SOUTHERN SAN JOAQUIN MUNICIPAL UTILITY DISTRICT

Addendum 1

**SPECIFICATIONS NO. 26-02
CARATAN RECHARGE PIPELINE**

August 27, 2026

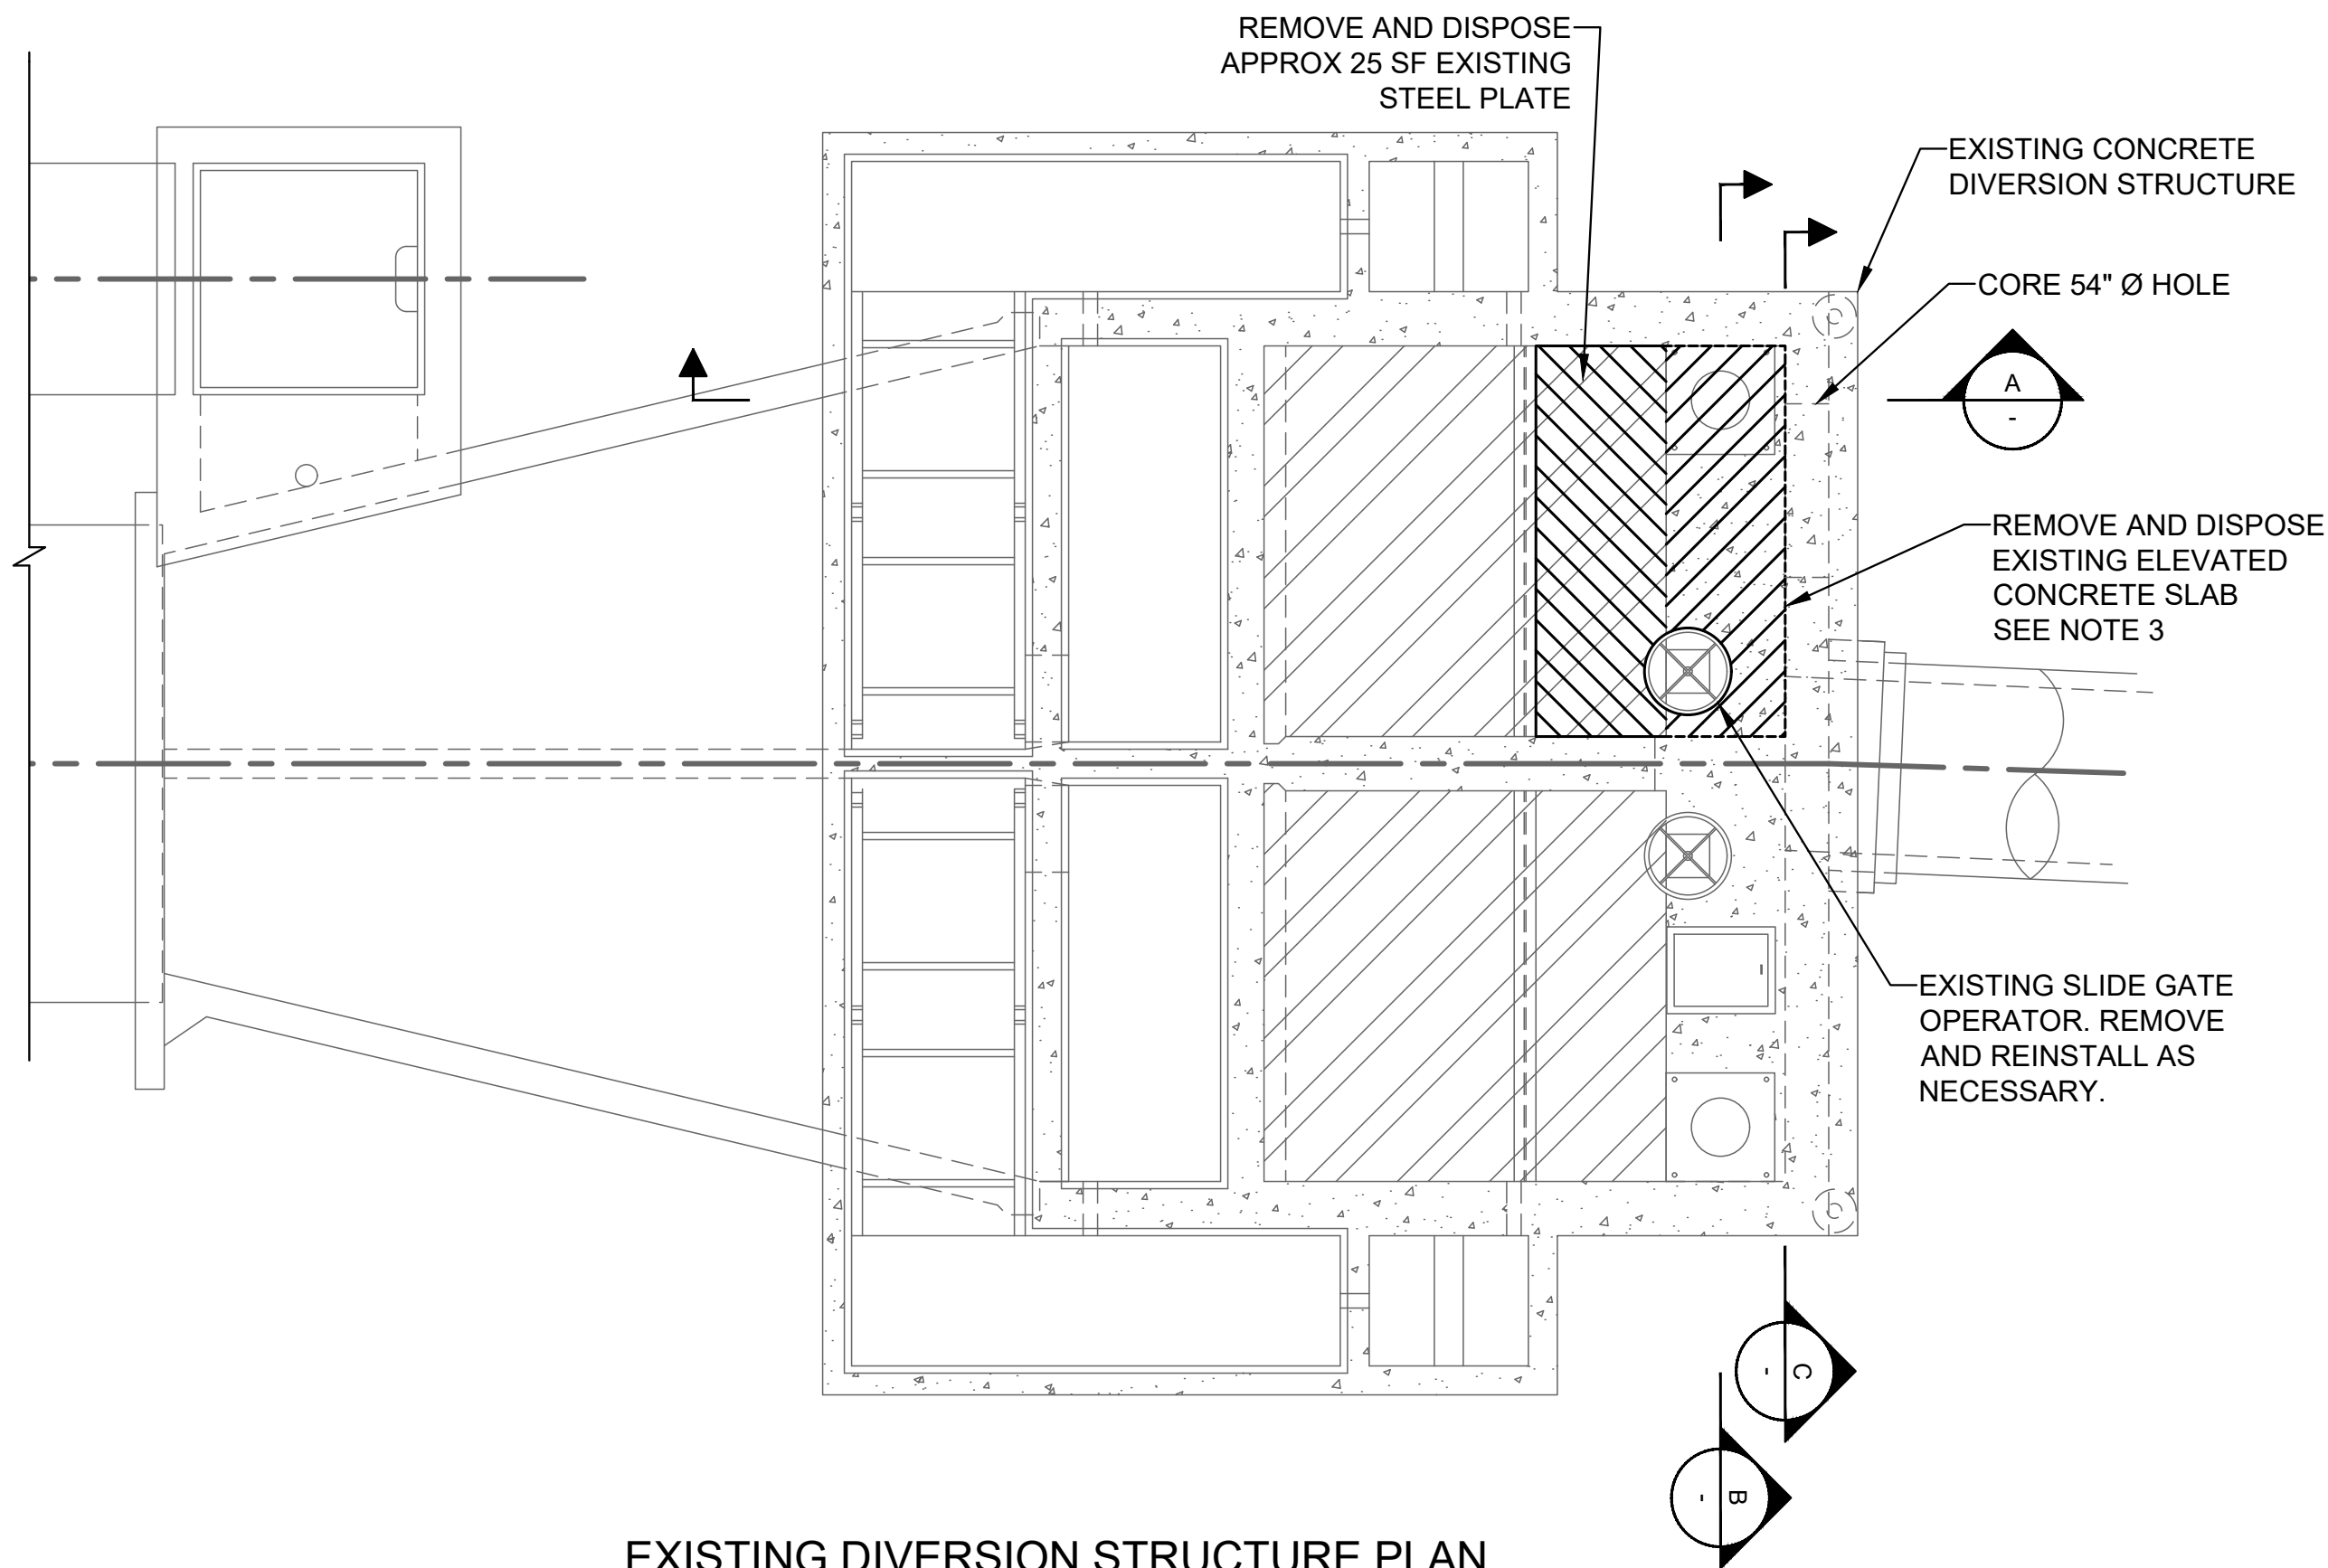
- a. Revise Section C/C-05 to change the core hole from 54” to 52”. The drawing is reissued.
- b. Revise Detail 7/C-08 to reflect a 52” core hole. The drawing is reissued.
- c. Revise Appendix C District Furnished Items to include the slide gate shop drawing.
- d. Revise callouts for the Diversion Structure New Connection Plan Detail and the Section A/C-06. Added wall thickness dimension on Detail 1/C-06 and elevation callout removed on Section B/C-06. The drawing is reissued.
- e. Revise Detail 2/C-07 to modify the steel plate dimensions per the slide gate shop drawing. The drawing is reissued.
- f. Revise Detail 1/C-08 to modify the steel plate dimensions per the slide gate shop drawing. The drawing is reissued.
